**Response to  
Request for Additional Information No. 412(4744), Revision 0,  
Supplement 9**

**U.S. EPR Standard Design Certification  
AREVA NP Inc.  
Docket No. 52-020  
SRP Section: 03.07.02 - Seismic System Analysis  
Application Section: 03.07.02**

**Question 03.07.02-73:****RAI from Audit, 4/26-30, 2010**

**Figure 03.07.02-73-1—Contours of Computed Maximum Normal Dynamic Soil Pressures on Shear Key Outer Sidewall Surface, Analysis Case 2sn4ue-m**

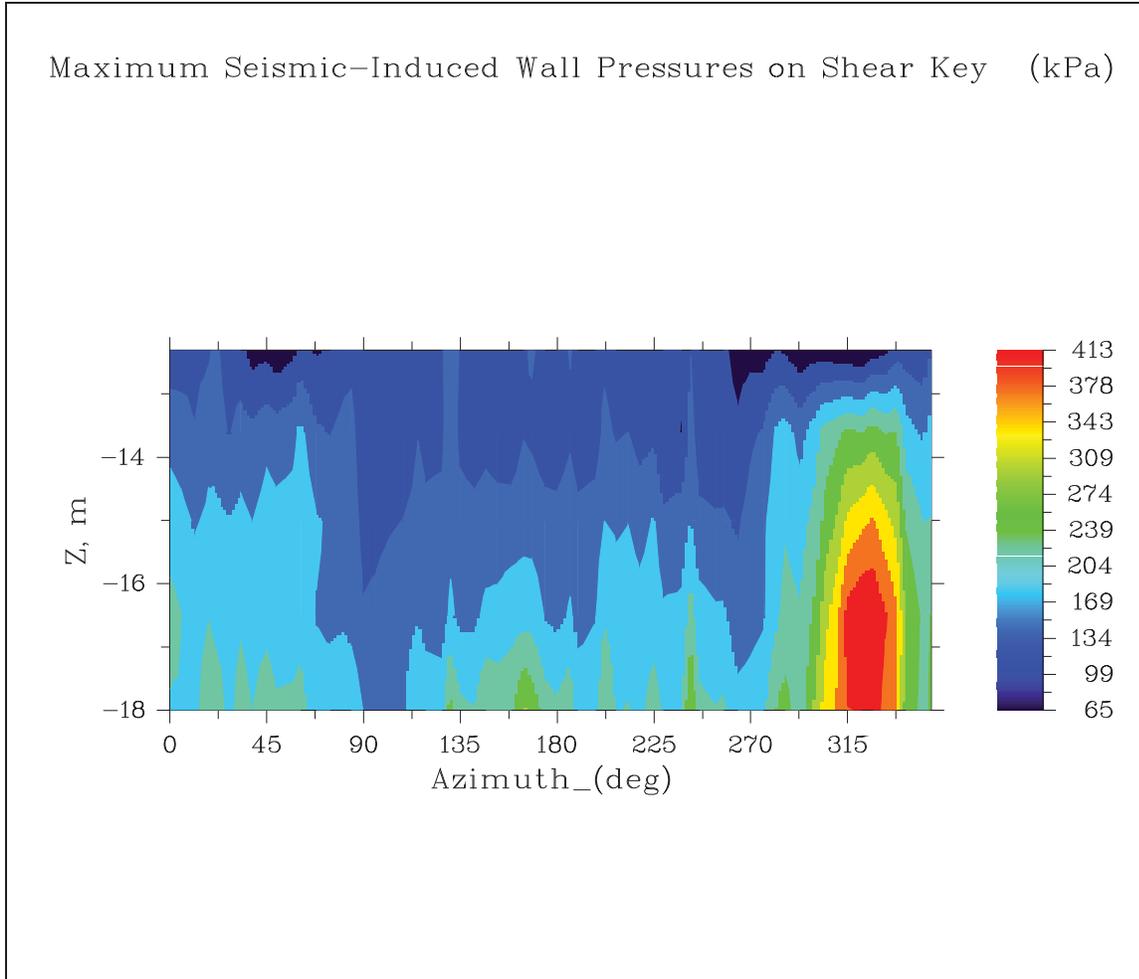
During the staff review of the calculation documenting the SSI Analysis of the Nuclear Island (NI) Common Basemat Structure (Calculation No.32-7002884-000), there were two items identified which require further clarification to assure that the design of the NI meets the earthquake design requirements of GDC 2. First, it was noted that pressure distributions on the shear key (see example on page 419) appear to be oscillatory and somewhat random. AREVA is requested to describe how the distribution was determined, whether or not it is valid, and if valid, how this pressure distribution will be used for earthquake design of the shear key and for the calculation of interface loads between the shear key and the NI foundation mat.

Shear key plots were developed and provide the maximum pressure distribution that considers the entire earthquake time history. Figure 03.07.02-73-1 represents the pressures on the shear key that occur at different times during the earthquake, and can subsequently have a pattern that appears oscillatory and random. However, the pressure distribution at a specific time reveals that the pressure distribution is more uniform, with about half of the shear key resisting compressive forces, and the other half resisting tensile forces. Figure 03.07.02-73-2 shows the pressure distribution at different elevations of the shear key for the instant of time that the maximum pressure occurs for that elevation. Figure 03.07.02-73-3 provides the stress distribution for  $z = -16.040$  m from Figure 03.07.02-73-1.

**Figure 03.07.02-73-4—Analysis Frequencies 0.1 Hz to 25 Hz**

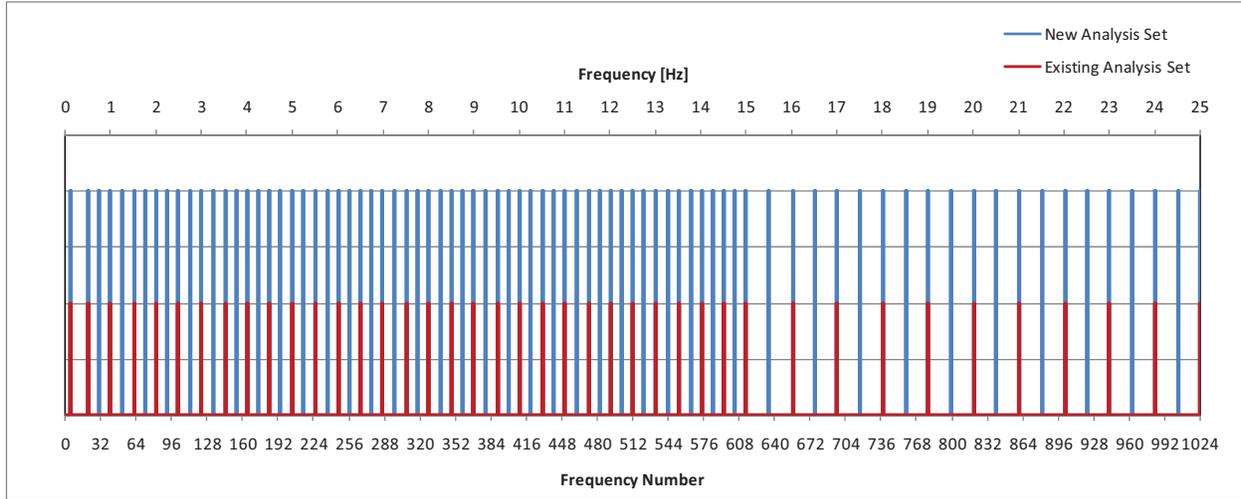
Second, many of the transfer functions such as those on page 696 of the calculation exhibit spikes. AREVA is requested to describe the cause of these spikes and to quantify the impact these spikes have on the stability of the computed seismic response of the NI structure.

The impact of transfer function spikes on the stability of the computed seismic response was assessed in a case study for soil case 2sn4ue. Soil case 2sn4ue, for uncracked concrete, was evaluated because it has significant seismic response and transfer function spikes. A total of 65 computed frequencies ranging from 0.1 Hz to 50 Hz represent the existing analysis for soil case 2sn4ue. An additional 124 computed frequencies were combined with the 65 frequencies for a total of 189 computed frequencies ranging from 0.1 Hz to 50 Hz. Figures 03.07.02-73-4 and 03.07.02-73-5 show the computed frequencies for the existing analysis and the case study.
